Gen 1 trailer tongue reinforcement

BULLETIN NO.	DISTRIBUTION DATE	C LASSIFICATION	TIMELINE	WORK INSTRUCTION
26-01	August 26, 2026	Service	Immediate	ASWI-59

REINFORCEMENT ARRANGEMENT — DRAWING A79932 REV 01

Fig. 2 — Area to inspect. Check the full length of the bend where the tongue meets the frame, on both sides of the trailer.

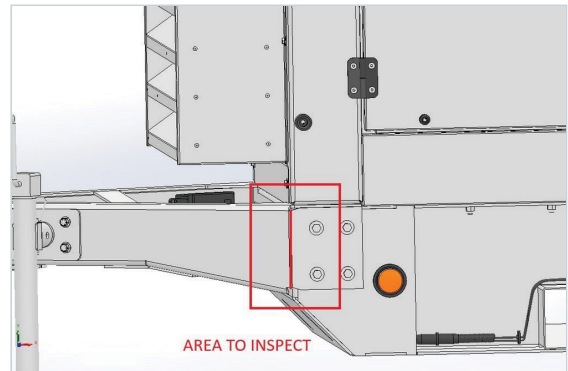
Cornell has received reports of cracking and failure at the trailer tongue joint on Gen 1 trailers. The cracks start along the bend in bent-plate tongue D63856, where the tongue meets the frame.

Fig. 3 — A79932A, bolted, both sides. Bolt the plate to the tongue before drilling, then use the plate as the template to drill 3x Ø.56 through tongue D63856.

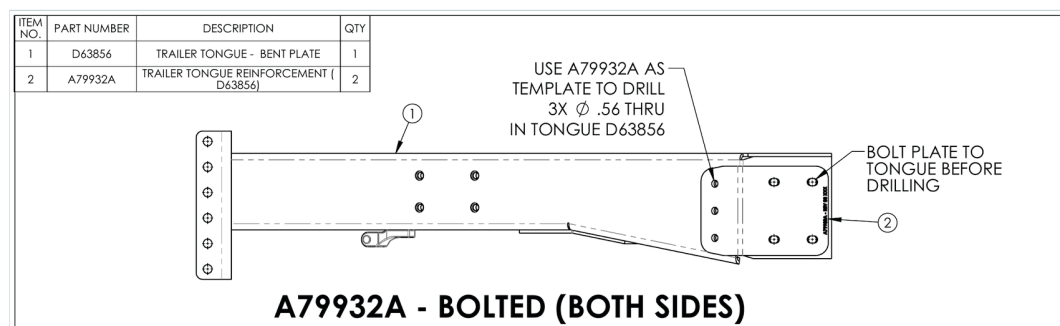
Cornell has released reinforcement plate A79932, which bolts onto the tongue in the field — two plates per trailer, one each side. Where damage is already present, Cornell will supply a replacement tongue with the reinforcement factory-installed.
